**WILSONVILLE CITY HALL
DEVELOPMENT REVIEW BOARD PANEL A**

A. Resolution No. 329.

12-Lot Single Family Subdivision (Ash Park): Randy Myers, Brownstone Development - Applicant. The applicant is requesting approval of a modification to a previously approved condition of approval, Tentative Partition Plat, Modified Stage I Preliminary Plan, Stage II Final Plan, Tentative Subdivision Plat, Site Design Review, Type C Tree Plan and Waivers for a 12-lot single family subdivision. The subject property is located at 8195 SW Maxine Lane on Tax Lot 2700 of Section 13B, T3S, R1W, Clackamas County, Oregon. Staff: Connie Randall

Exhibit A1
Staff Report
Wilsonville Planning Division
Ash Park 12-Lot Single-Family Subdivision at 8195 SW Maxine Lane

PRELIMINARY PLAT ASH PARK

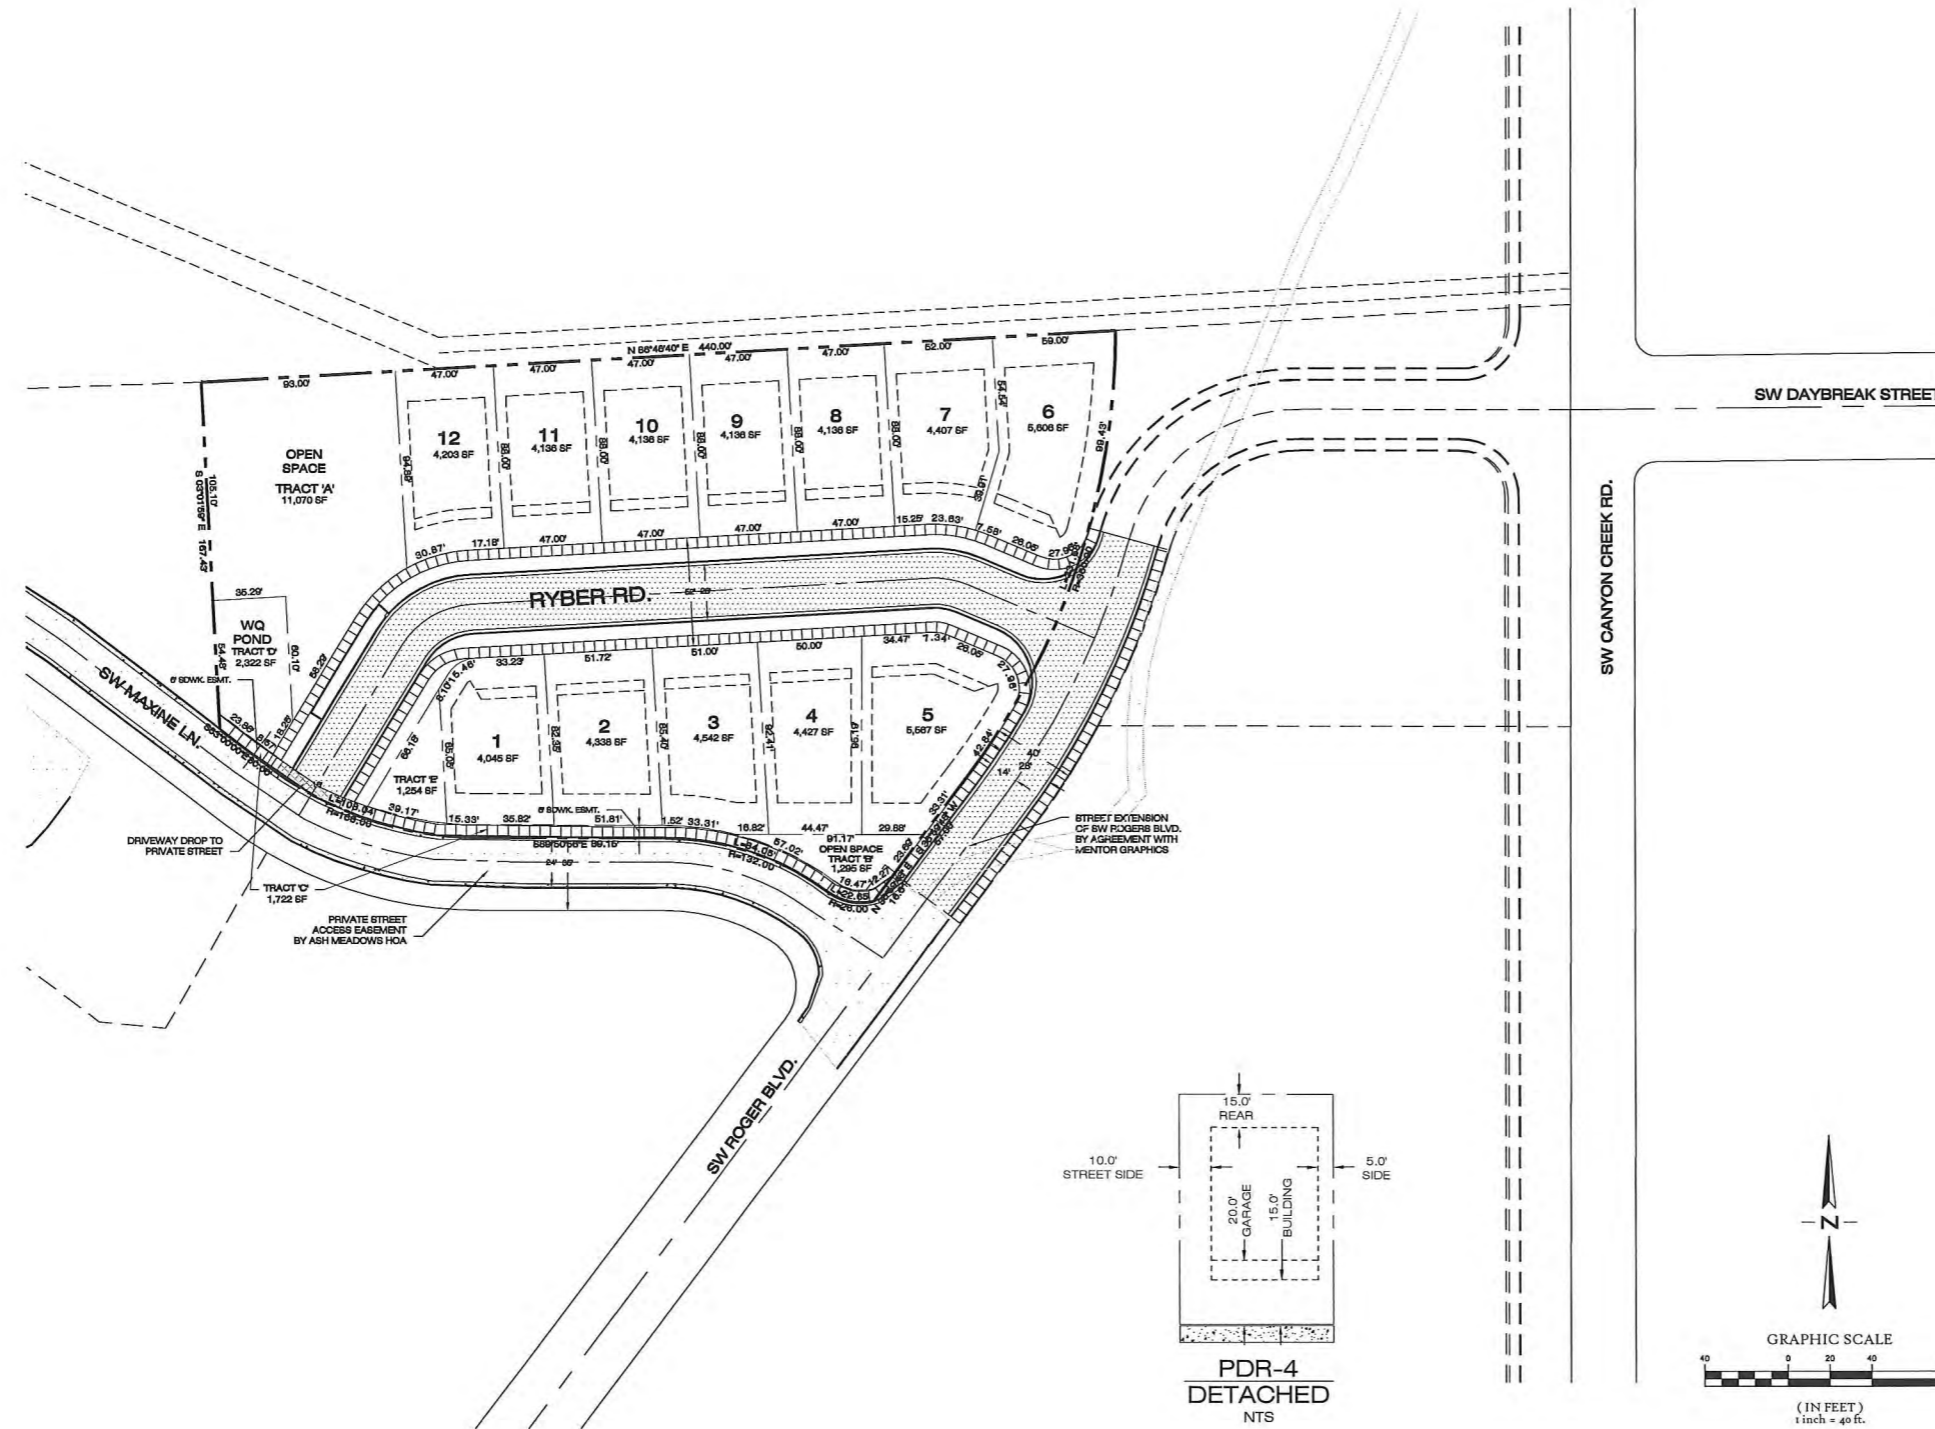
13. FULL-SIZE AND REDUCED-SIZE DRAWINGS DO NOT MATCH. In particular, lot and tract configurations are not consistent. On Sheet 1 of 7 (both sizes), see particularly, Lots 2 6, and 9 15. The Preliminary Utilities Plan (Sheet 6 of 7) is different in the two drawing formats, particularly regarding the detention pond source and outfall. The drawings are inconsistent, throughout both size formats of the submitted drawings. Please revise the drawings, and corresponding data in the narrative, to provide a consistent proposal.
